ADDENDUM 1 TO:
ANALYSES
OF
THE ADEQUACY
OF THE
DAVIS-BESSE NUCLEAR POWER STATION
ONSITE ELECTRICAL
AUXILIARY DISTRIBUTION
POWER SYSTEM
VOLTAGES

Prepared
in
Response
to the
Nuclear Regulatory Commission
Request for Additional Information
of
November 14, 1980

December 30, 1980

Davis-Besse Nuclear Power Station
Figure No. 1

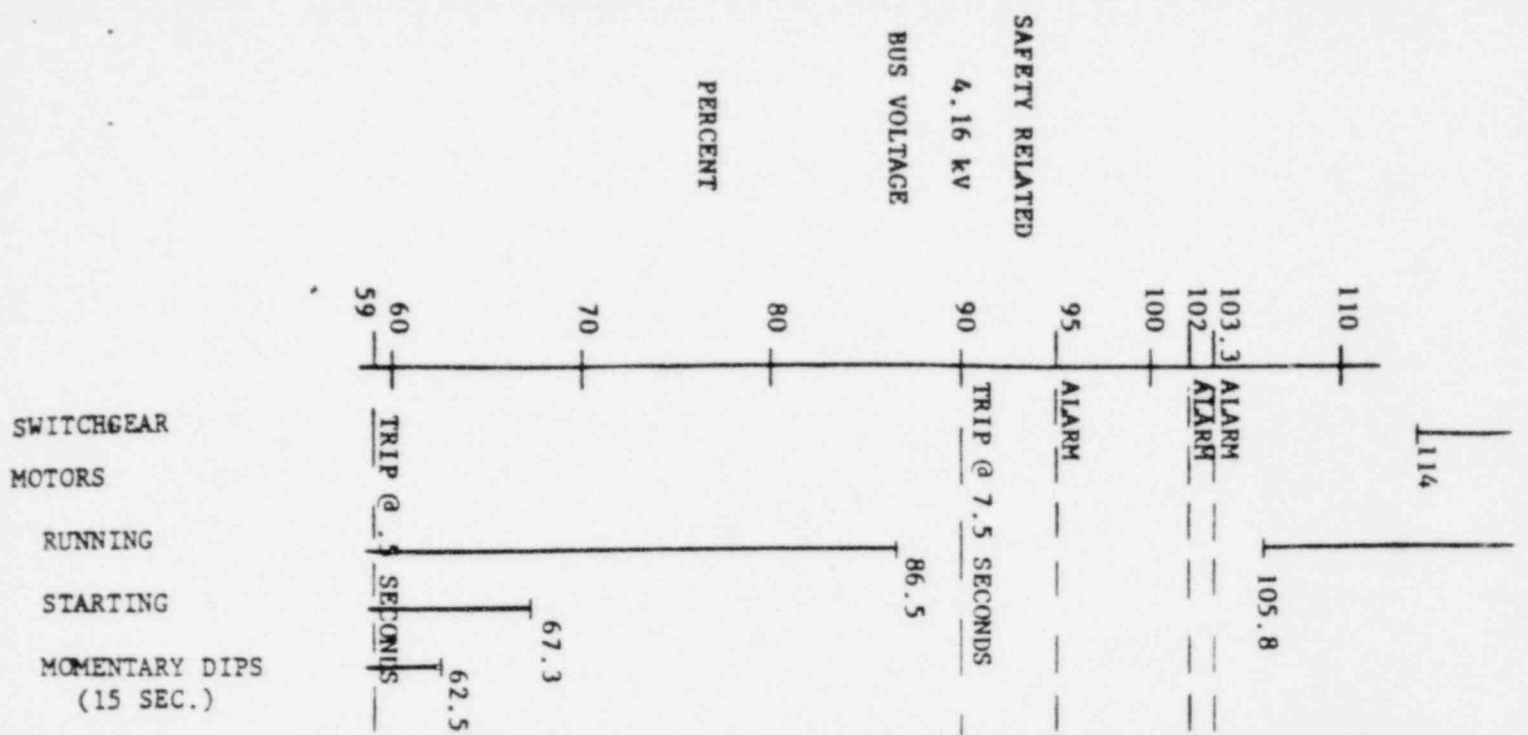
Question 2: The single line diagram included in Reference 2 does not indicate any non-Class 1E 4160 volt buses. However, Reference 2 states that the analyses were performed starting the largest 4.0 kV motor (condensate pump). What is the source of power for 4.0 kV condensate pump motor?

Response: On the single line diagram (Figure 1) included in our report, the non-Class 1E 4160 volt buses are numbered "C2" and "D2". Only the portion of the single line that is inside the dotted lines is Class 1E.

Davis-Besse Nuclear Power Station
Fig. No. 5
Sht. 1 of 2

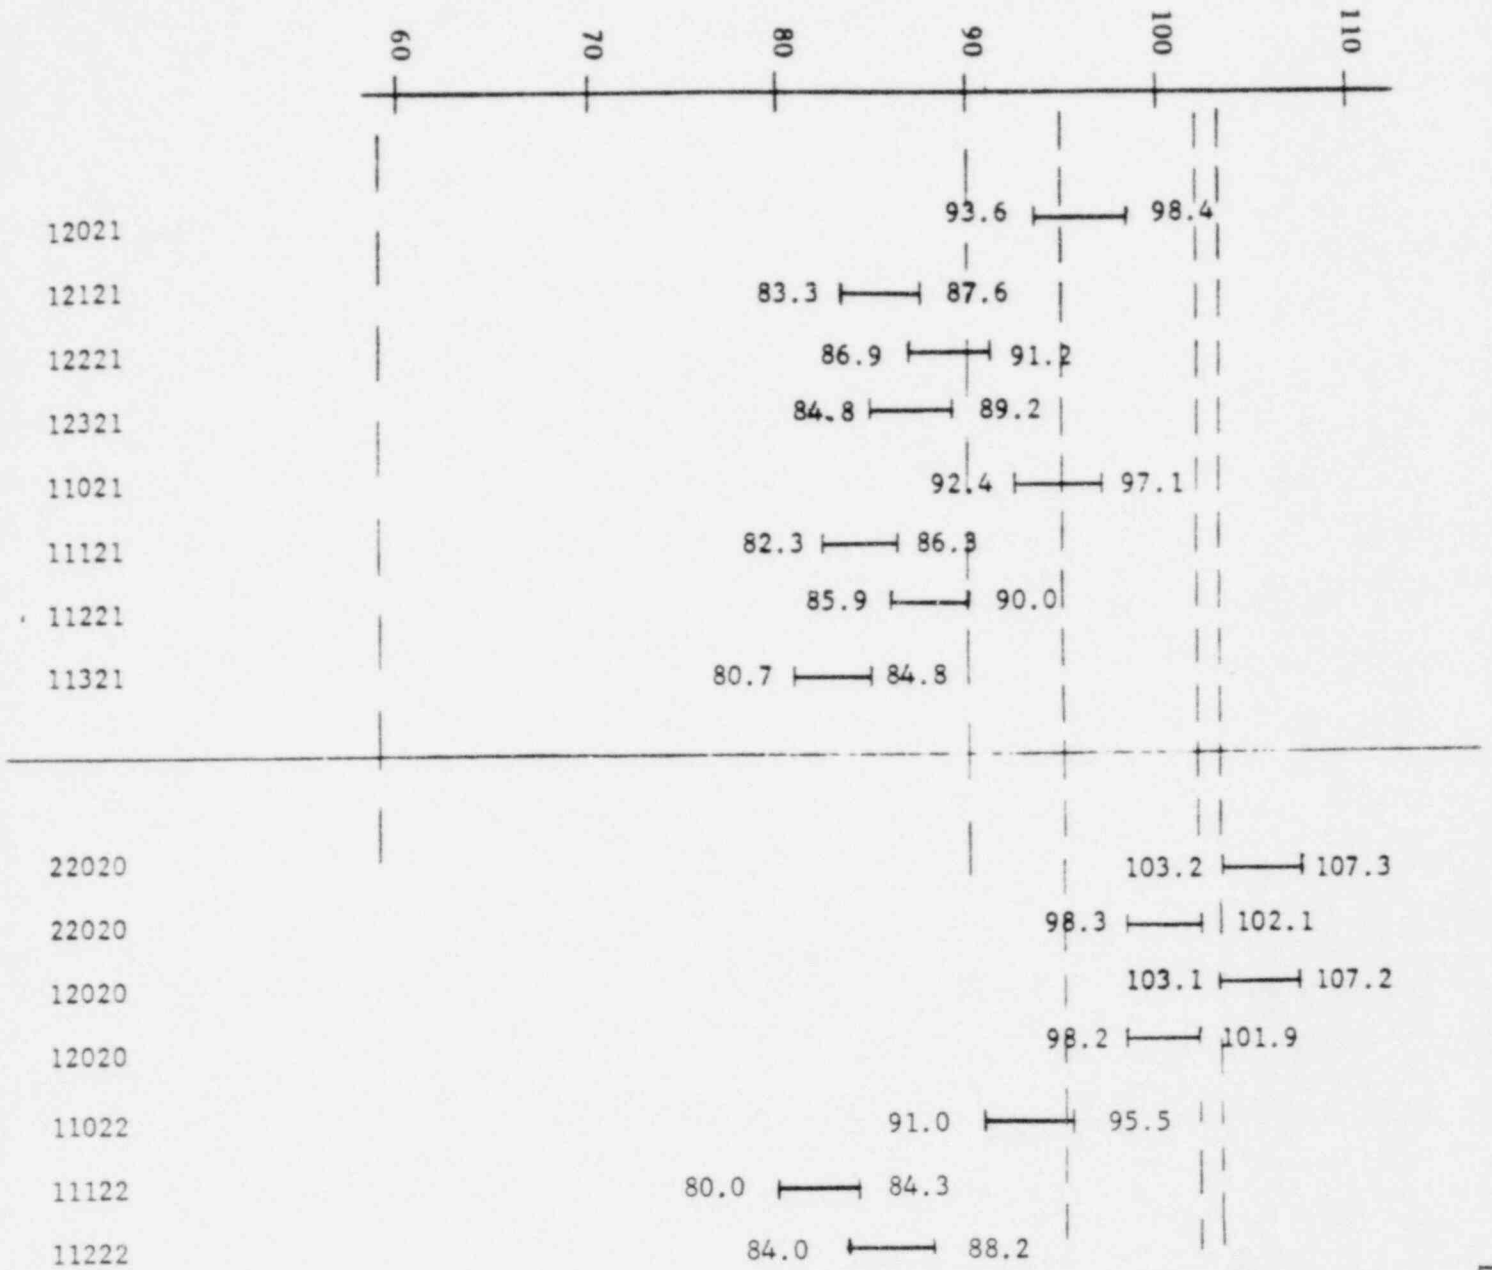
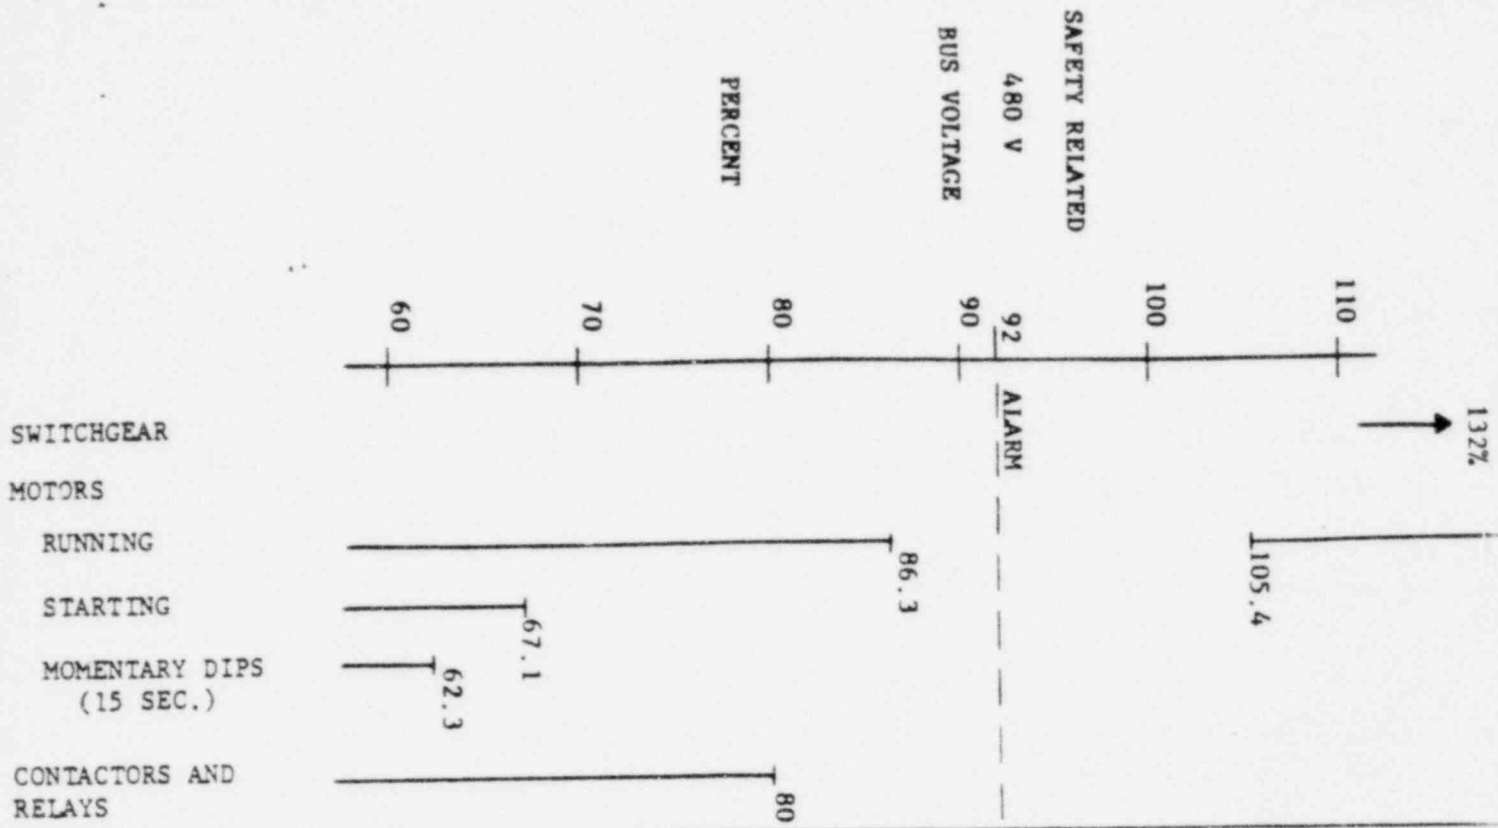
Question 1: The intent of Guideline 3 (Ref. 1) is that the analysis should include the effects of starting large non-Class 1E loads under worst case conditions, including all Class 1E equipment running, and determine if all Class 1E equipment will operate within their required operating voltage range and that separation from offsite power sources will not occur due to operation of the undervoltage relays. In your analysis (Ref. 2), does the full auxiliary electrical load used in the analysis of starting the reactor coolant pump and condensate pump include fully loaded Class 1E buses? If not, you are requested to provide this analysis.

The analyses show that the transient voltage dips caused by starting a reactor coolant pump or condensate pump do not fall below the voltage values needed by the Class 1E equipment to traverse the transient (see revised Figures 5 and 6). Class 1E equipment is not required to actuate during the transient since all Class 1E loads are running in these cases.
